Natural Resources Division

Project Review Summary

Prepared for the Environmental Advisory Board

June 25, 2025

Wellen Park MOB-PPRE-25-02137

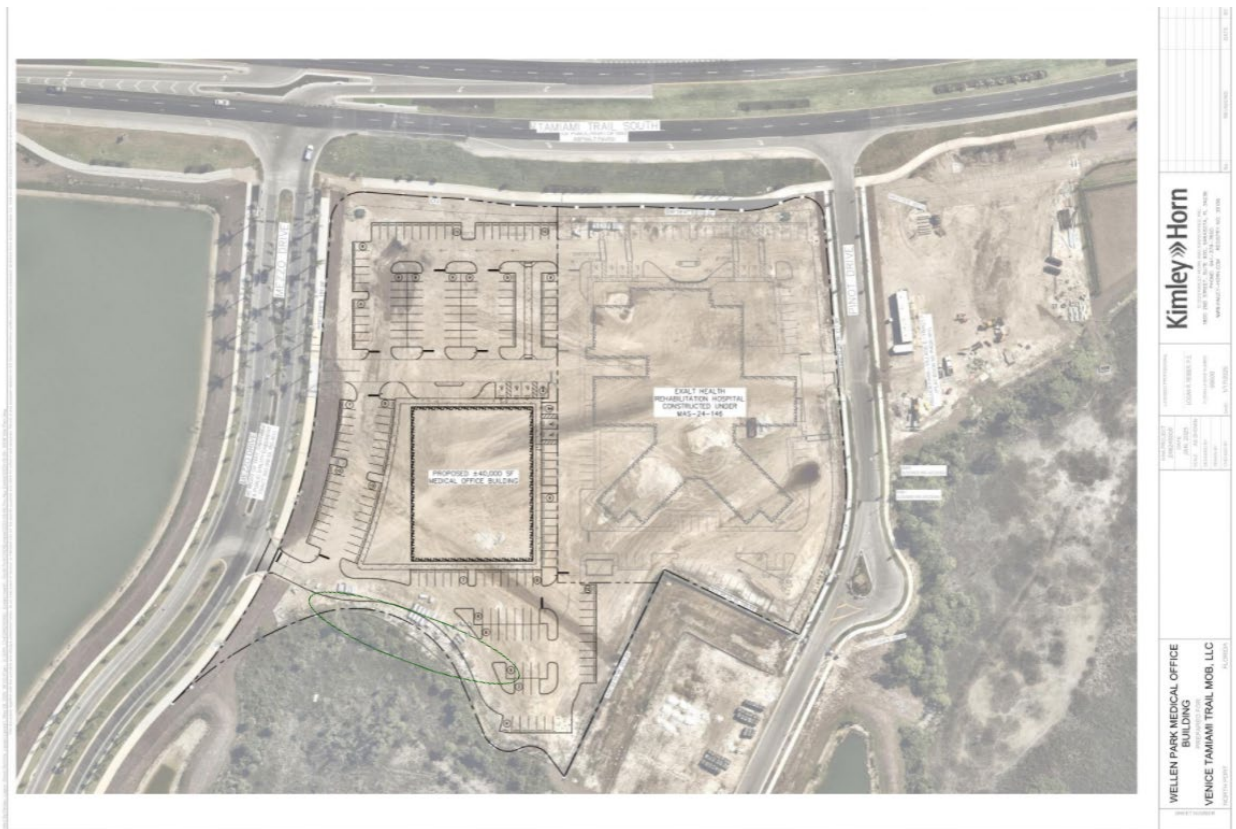
Overall Comment: The ULDC mandates that a landscape plan, signed by a licensed landscape architect or engineer, is essential for site development plans. All projects must adhere to Sustainable Development and low-impact development design standards, which focus on reducing impervious surfaces and incorporating native landscaping. Additionally, compliance with the West Villages Pattern Plan's Section 10 Design Standards for Landscaping and Irrigation is required. For commercial developments, a minimum of 20% of the site must be designated as open space. Buffer zones around wetlands must align with jurisdictional boundaries and ecological importance, and there are stringent maintenance requirements for preserving native vegetation within these zones.
